# LEE COUNTY SOLID WASTE ENERGY RECOVERY FACILITY (SWERF)

## SIX NESTS OF MONITORING WELLS

LEE COUNTY - FORT MYERS FLORIDA  
 PROPOSED ON-SITE  
 MONITORING LOCATIONS

FIGURE 13

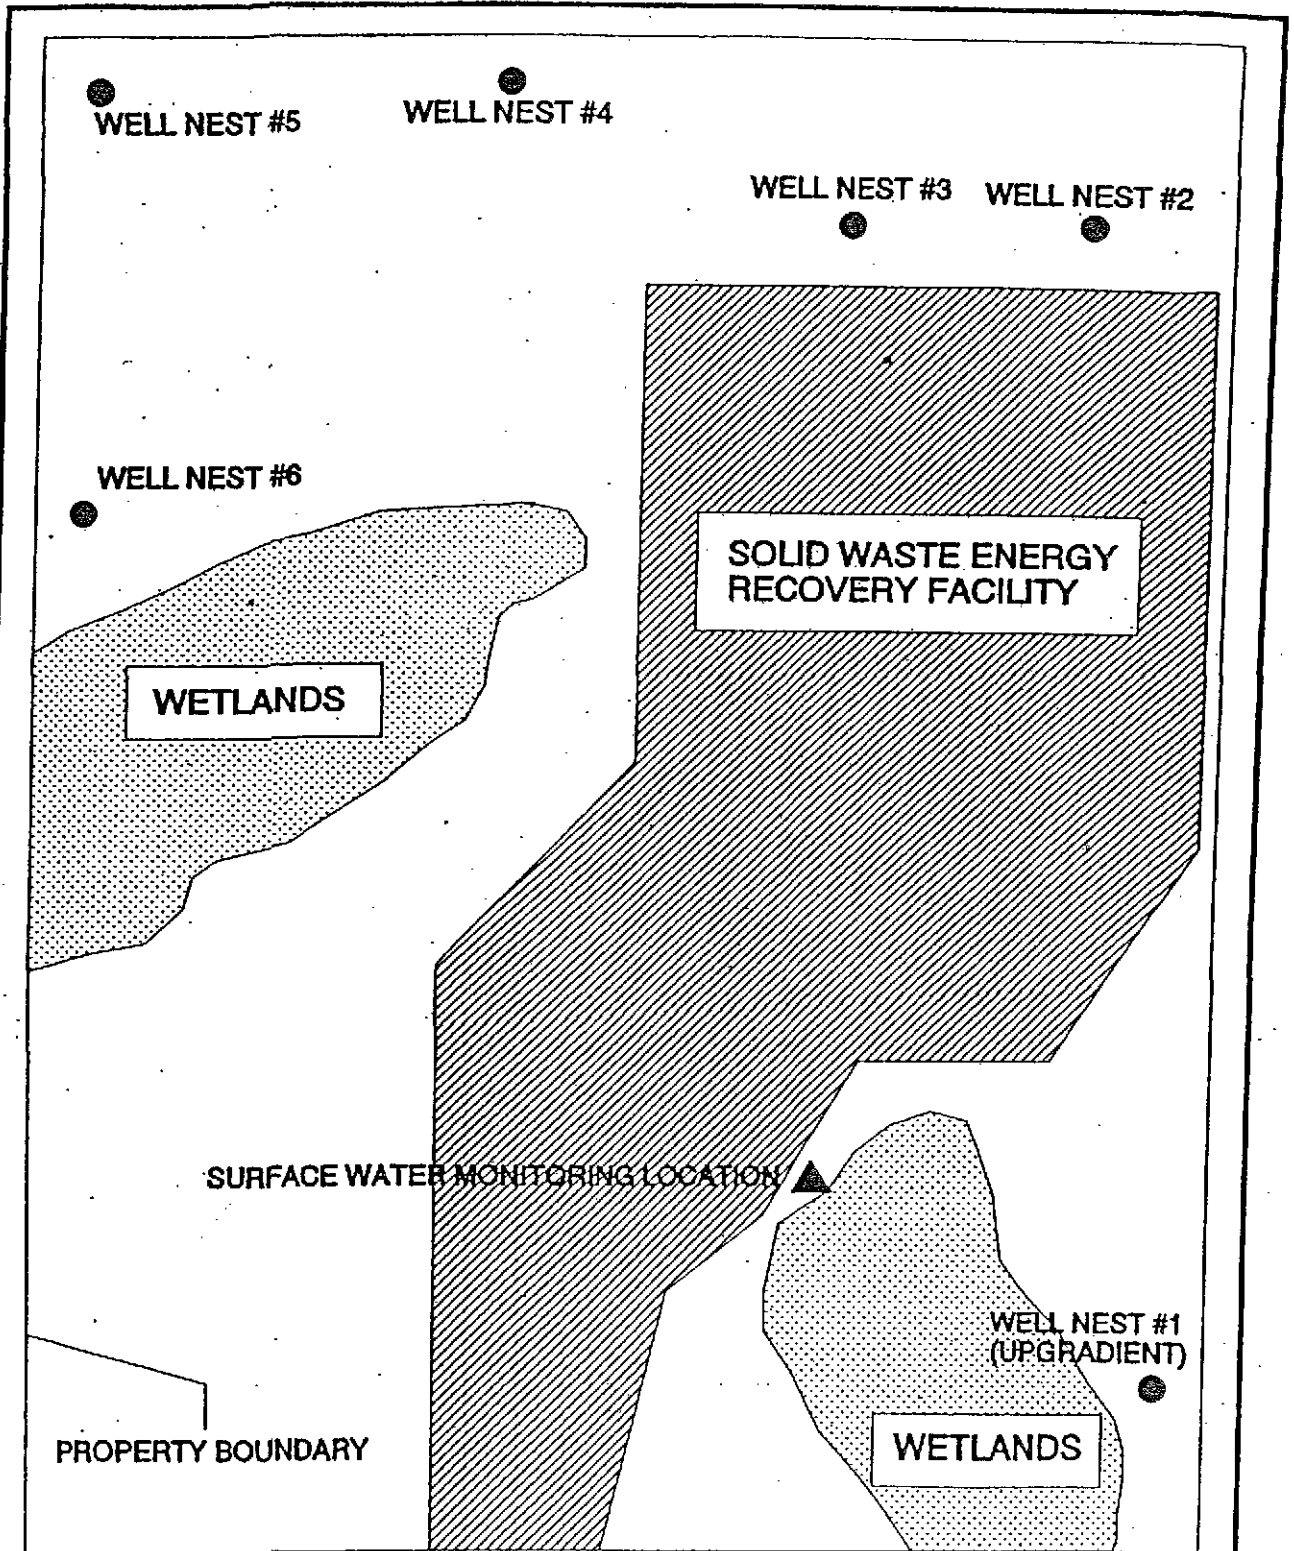
\* Should we look at this [beginning]  
down gradient vs up gradient?

Last modification was 1996.  
Current version of Chapter 6-701  
is 5/27/01. Change parameters  
or keep the same?

Leachate from ash is  
"extra salty." Ash leachate  
here should be comparable to  
ash leachate results from  
the landfill. High sodium  
leachate from artesian well or  
ash leachate? DUV
